Attachment 1 – Existing and Proposed Signage Minnivale Rest Area -

Recommended New Signage:

G. Update this wooden signage (three options), or remove entirely (one option...):

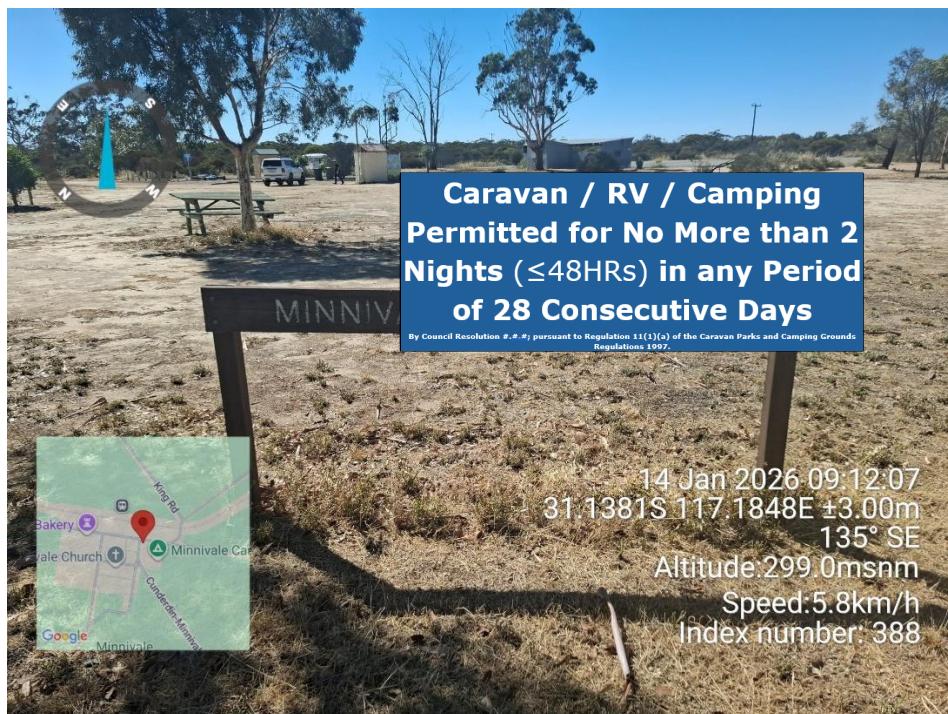
Option 1:

“Minnivale 48HR Rest Area”

Option 2:

“Minnivale Former Tennis Grounds”

Option 3:

Or remove entirely....
